NEI 17-02

Tornado Missile Risk Evaluator (TMRE) – Resolution of NRC Staff Comments

- Resolve remaining NRC staff comments on the TMRE Guidance Document (GD) - NEI 17-02 as described in ML17235B148.
 - Meeting November 8, 2017 addressed NRC comments regarding structural engineering
 - Meeting today will address remaining NRC comments regarding risk modeling

Figure 3-1. Plan View of Safety Related Structures

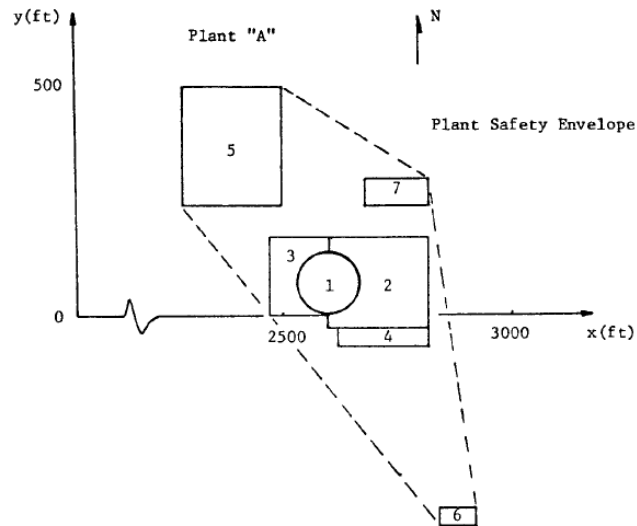
- Building 1 (Containment) is 230 feet tall, but lower portion of building is completely shielded by Buildings 2 (Aux Bldg) and 3 (Fuel Handling Bldg)
 - Aux Bldg is 80 feet tall and Fuel Handling Bldg is 60 feet tall, so all exposed surfaces of Building 1 are >30' above grade
- EPRI NP-768 Plant A TORMIS simulations assume uniform distribution of initial missile elevations from 5' to 50' above grade, so some missiles are within 30' of exposed surface on west (FHB) side of Building 1

- Use of containment data in deriving <30' MIP leads to lower (less conservative) <30' MIPs
- >30' MIPs are derived in a conservative manner, since they include entire surface of all buildings, including surfaces less than 30' above grade
- TMRE methodology provides conservative tornado failure probabilities, when compared to TORMIS-based failure probabilities in RG 1.200 HW PRAs (Appendix A)
- Sensitivity case factors (2.5x and 2.75x) are significantly greater than increase in MIP, if it were derived without Building 1

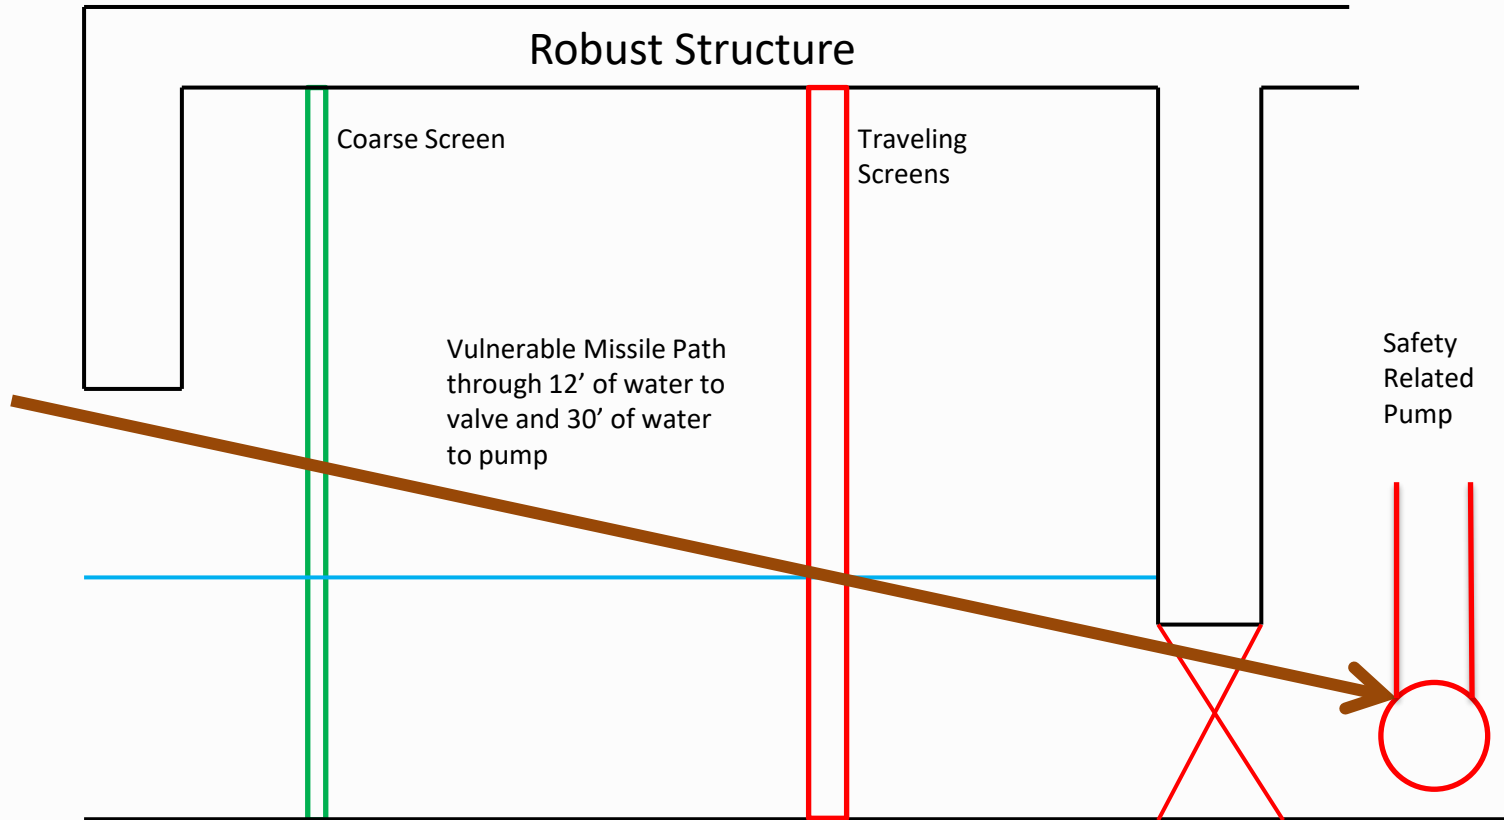
- Duke Energy determined that there is minimal value in documenting and having NRC review the technical justification for the De Minimis screening approach.
- Duke Energy withdrew the aspect of its LAR related to the De Minimis screening approach in letter dated January 11.
- As the De Minimis screening approach was described in NEI 17-02, Rev. 1, which was incorporated by reference into the LAR, the explicit aspects of the methodology requested to be withdrawn were attached as marked-up pages.
